REQUEST

Current Zoning: O-2 PED (office, pedestrian overlay)
Proposed Zoning: MUDD-O PED (mixed use development, optional, Pedestrian Overlay)

Approximately 0.94 acres located at the southeast intersection of Commonwealth Avenue and The Plaza, north of East Independence Boulevard.

PLANNING STAFF REVIEW

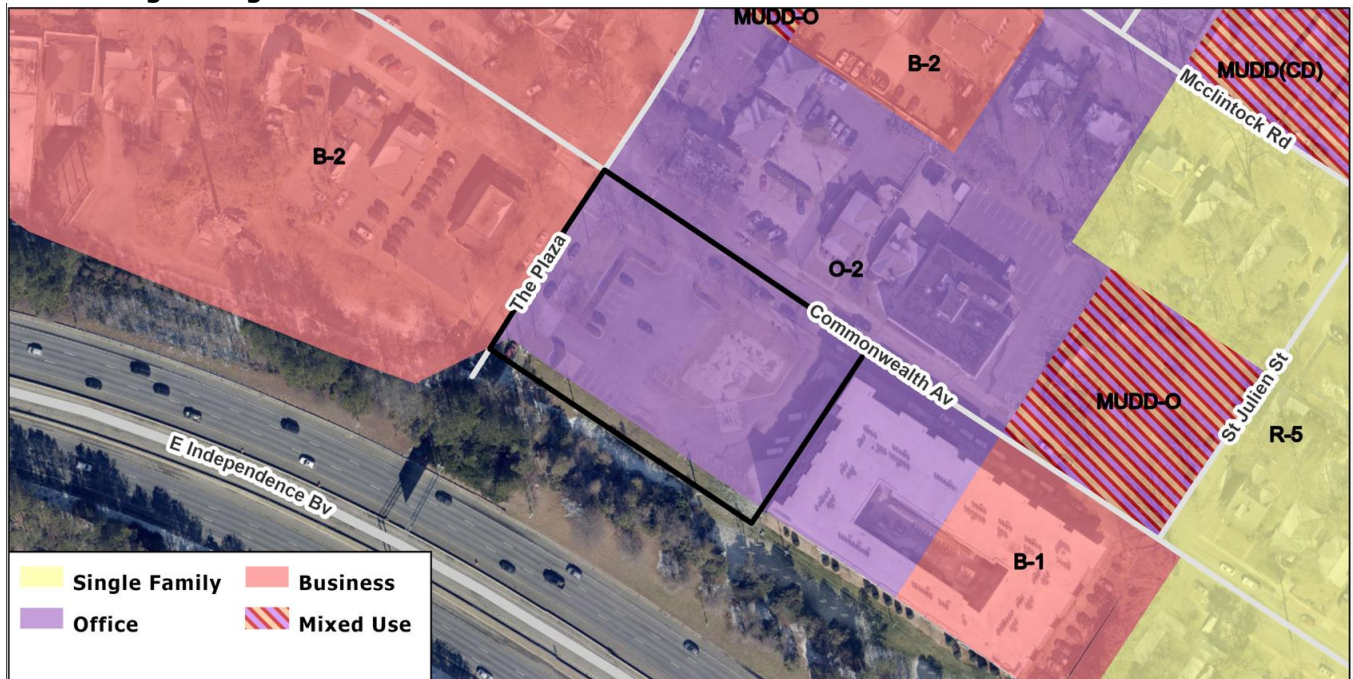
1. Show required right-of-way trees.

3. Reduce the maximum height to provide contextual sensitivity to the surrounding building forms.
4. Revise note 7 under the Design Guidelines to commit to community benefits to achieve building height above 80'. Commit to specific community benefits.
5. Identify building envelopes(s) rather than one development area.
6. Remove optional provision allowing for a drive-through.
